P 515320-A

SEWAGE DISPOSAL SYSTEM  
HOWARD COUNTY HEALTH DEPARTMENT  
BUREAU OF ENVIRONMENTAL HEALTH  
410-313-2640

SUBDIVISION Big Branch Overlook LOT NUMBER 7 ADDRESS 14033 Big Branch Drive

P-515320-A

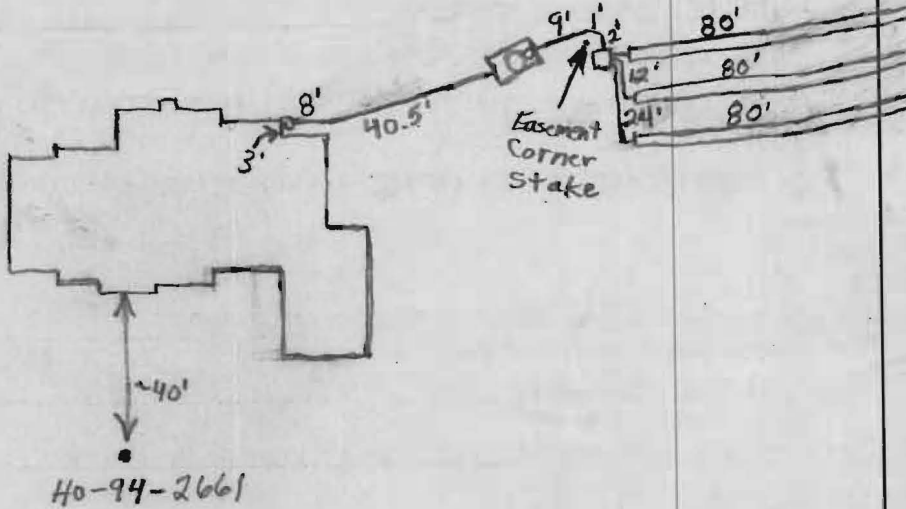
PRE-CONSTRUCTION INSPECTION: 7/11/01-INSPECTION CANCELLED - FRU 7/13/01 Builder to install grinder pump in basement. Sd pumped system won't be necessary.

INSPECTION COMMENTS: Otherwise installation as per B.P. plan. Easement staked. (BB)

7/18/01 Tank set. Need outlet baffle filter. (BB) 7/19/01 First trench done and second trench started. Need outlet baffle filter. (BB)

7/20/01 Everything finished. O.K. to cover. (BB)
